003027.00
Task 6

May 25, 2006

SUBJECT: WORK PLAN FOR CONDUCTING A PILOT STUDY FOR SOIL VAPOR EXTRACTION AND OZONE INJECTION, ADDENDUM NO. 1, PACE IN/OUT, DORRIS, CALIFORNIA

PROPOSED WELLS, PROBES, AND POINTS FOR PILOT STUDY

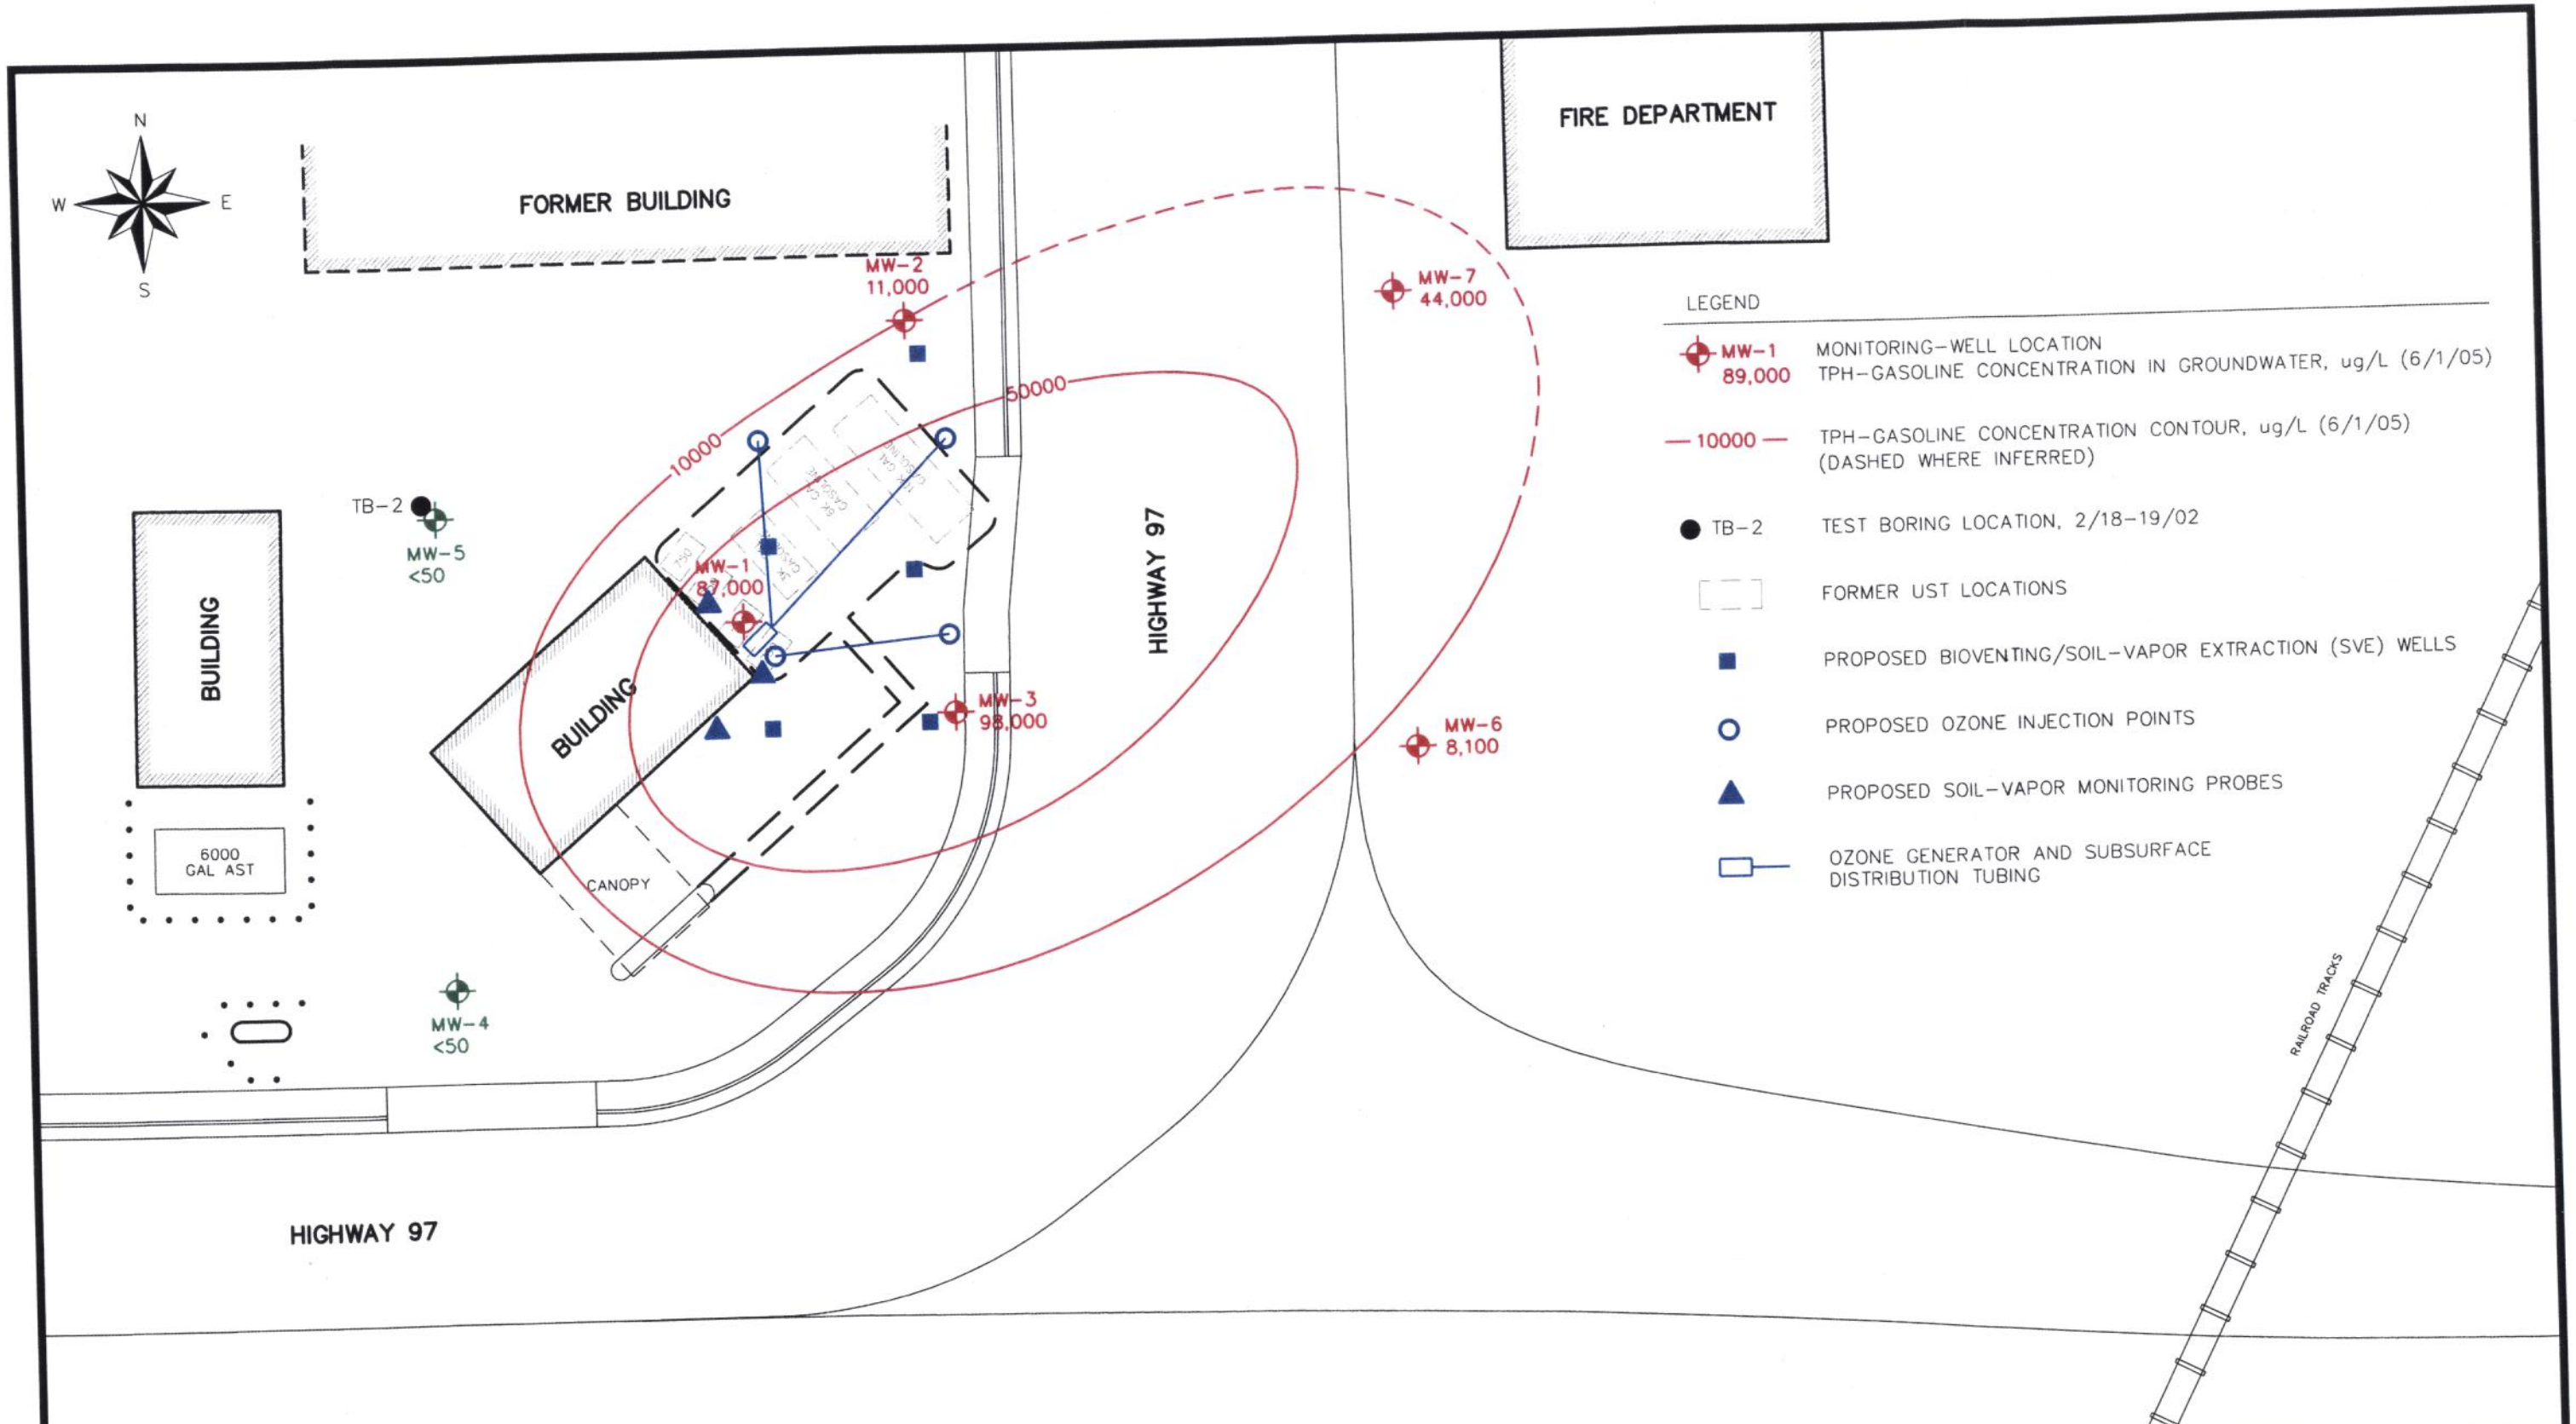
The pilot system will involve the installation of the following wells, in the locations shown in **Figure 2**:

TYPICAL CONSTRUCTION DETAIL FOR SOIL GAS MONITORING PROBE		LAWRENCE & ASSOCIATES 2001 Market Street, Room 523 Redding, CA 96001 Phone (530) 244-9703 Fax (530) 244-5021	SCALE: AS SHOWN DATE: MAY 24, 2006 JOB NO.: 003027.00
CLIENT: PACE IN/OUT	PROJECT: PILOT STUDY	DRAWN BY: B. GARTNER	FIGURE 3

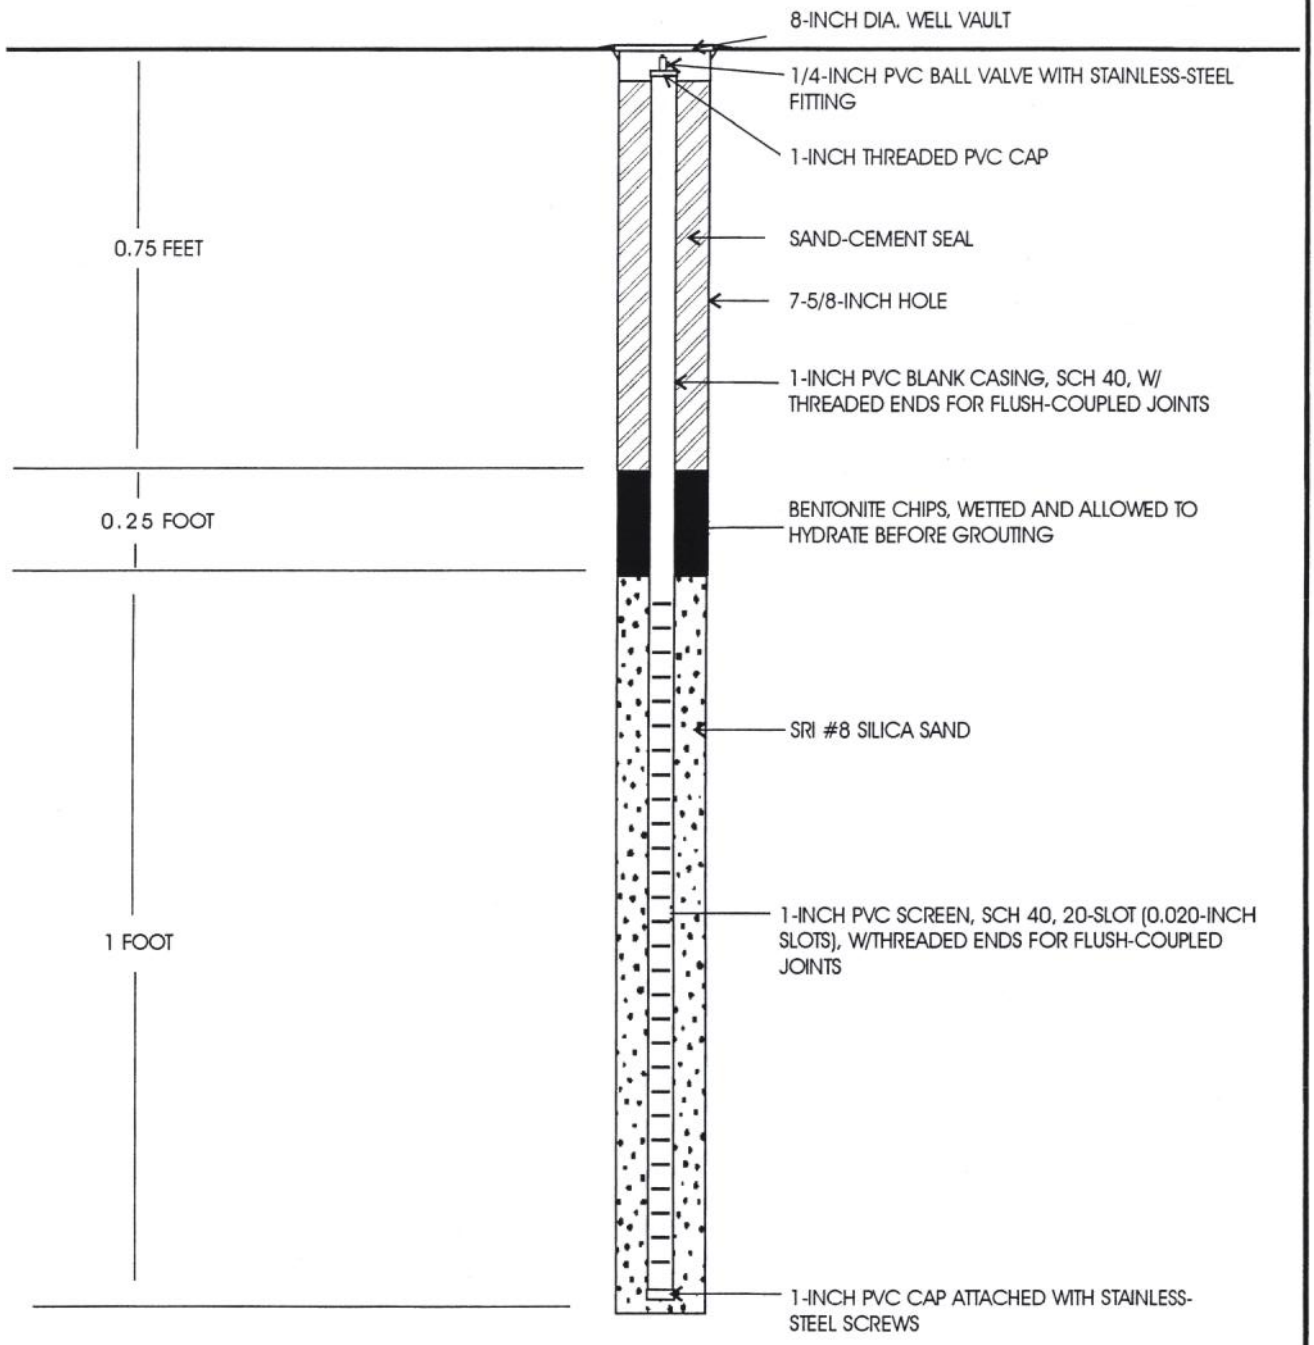
- Three 1-inch diameter soil-gas monitoring wells (see **Figure 3** for construction details), located two feet deep, immediately next to the building.
